# Groundwater Transfer Review Summary Form

Transfer/PA # T- 14522 (RA)

Application: T-14522

Applicant Name: ED Landholdings, LLC

**Well-to-Well Interference Analysis**

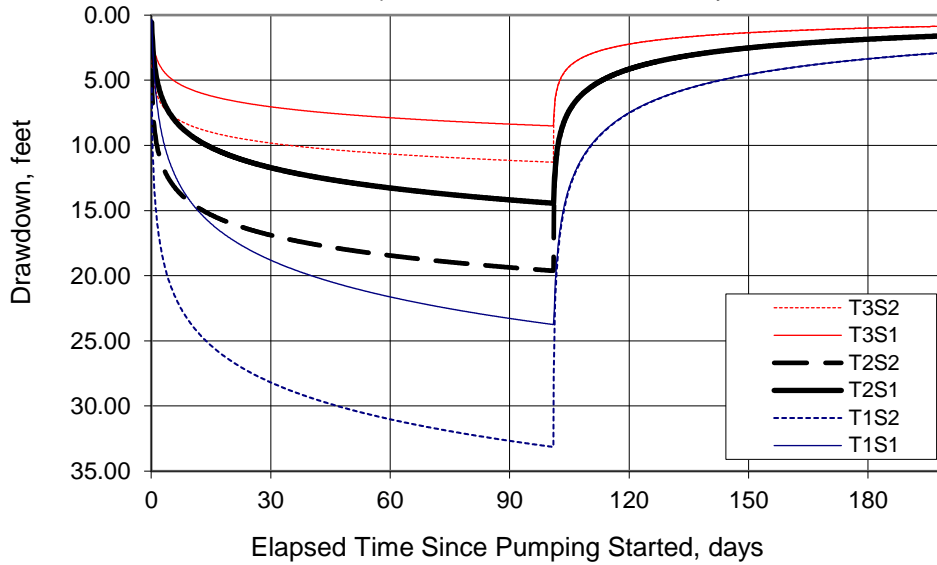
Yes  No If yes, explain: Interference between the proposed APOA and neighboring wells was analyzed using the Theis (1935) solution for drawdown in a confined aquifer (see Well-to-Well Interference Analysis, attached). Results of the analysis indicate that injury of the rights associated with MARI 4778 and 4781 is unlikely as a result of the proposed change.

Pumping rate, Q = 0.95 cfs [maximum rate for APOA]

Pumping duration, t<sub>pump</sub> = 101 days [approximate time to exhaust full duty of Cert 34795 at maximum rate]

Transmissivity, T1 = 1,600 ft<sup>2</sup>/day; T2 = 2,900 ft<sup>2</sup>/day; T3 = 5,400 ft<sup>2</sup>/day [Pumping test reports]

Storativity, S1 = 0.001; S2 = 0.0001 [Conlon et al., 2005, MSU]
